Response to Technical Circulation Comments

355 Franktown Road, Carleton Place

RE: Response to Technical Comments
355 Franktown Road – 3rd Review Comments
Draft Plan of Subdivision (File No, 09-T-23001)

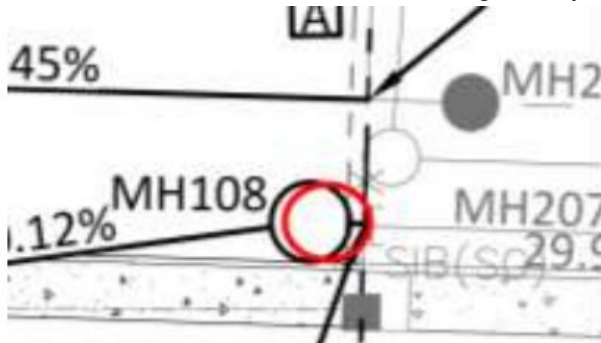
- 11 Storm manhole 108 should be connecting directly to the existing stub as shown below.

Storm manhole 108 has been shifted to tie directly into the existing stub.
